**MEMORANDUM**  
**City of Lancaster, California**

Date: April 20, 2005 **REVISED November 17, 2005**

Subject: **Rural LMDs**

Bollard Model No.VRBIC/100MH120/LG-P/NG-C  
Available from Kim Lighting (661) 968-5666

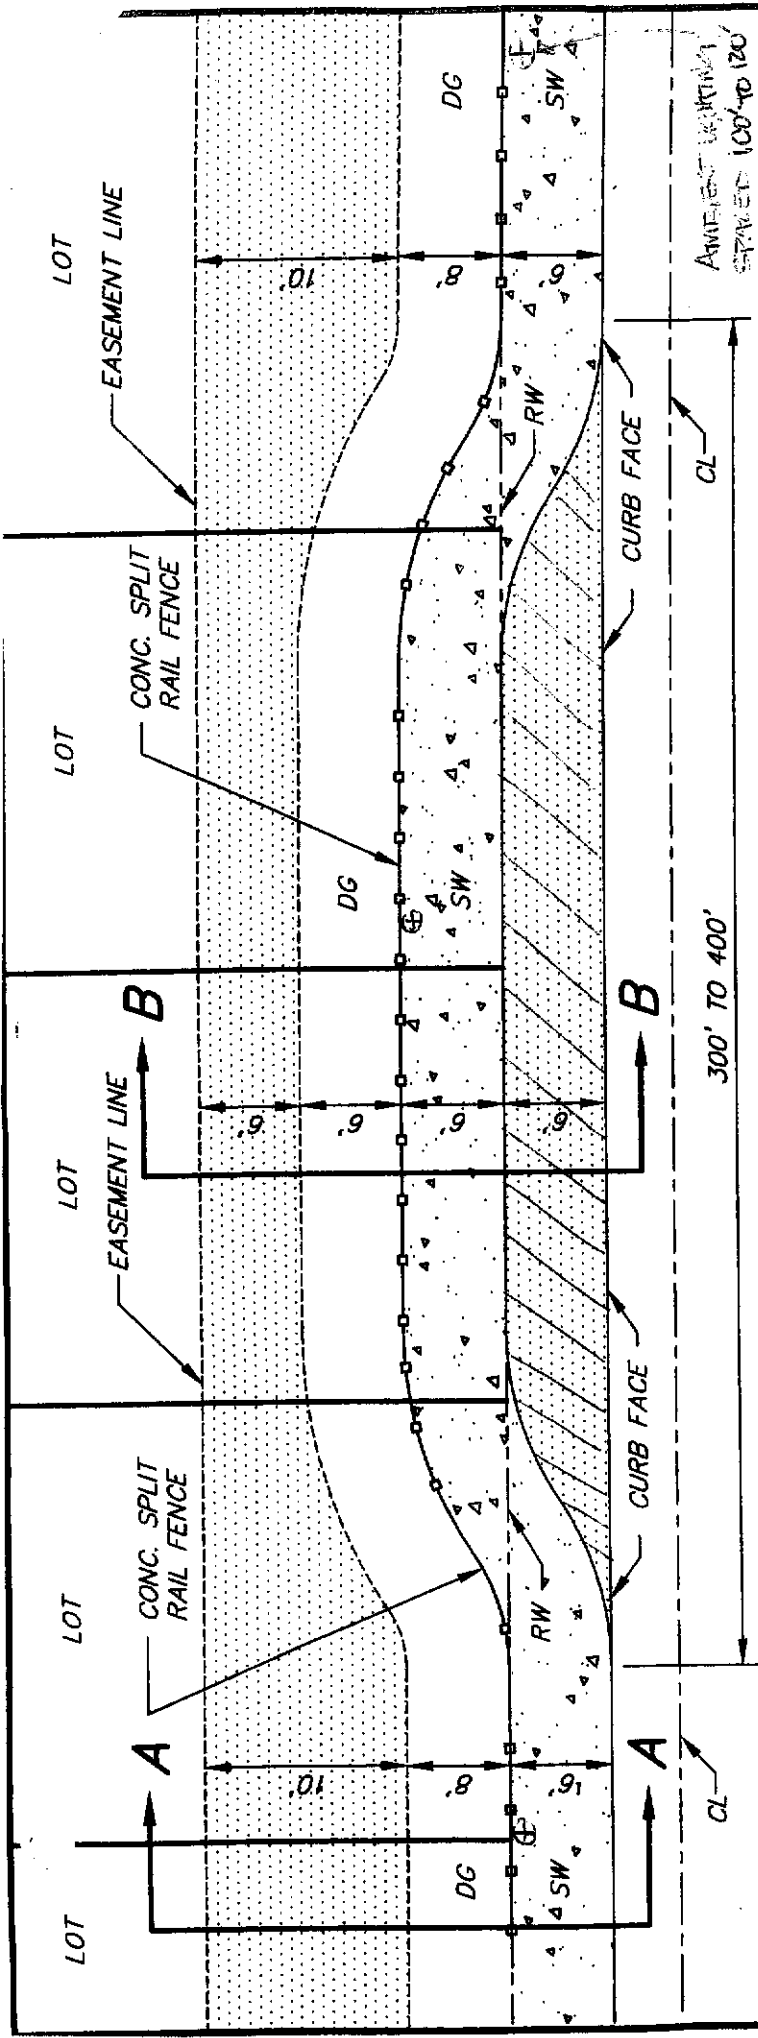
As discussed with Planning, the ambient lighting shall be a bollard style fixture:

The ambient lighting bollards are to be placed on the sidewalk side of the split rail fence and are to be spaced approximately 100 ft to 120 ft apart. See attached DRAFT Rural Street Standard detail for Meandering Sidewalk.
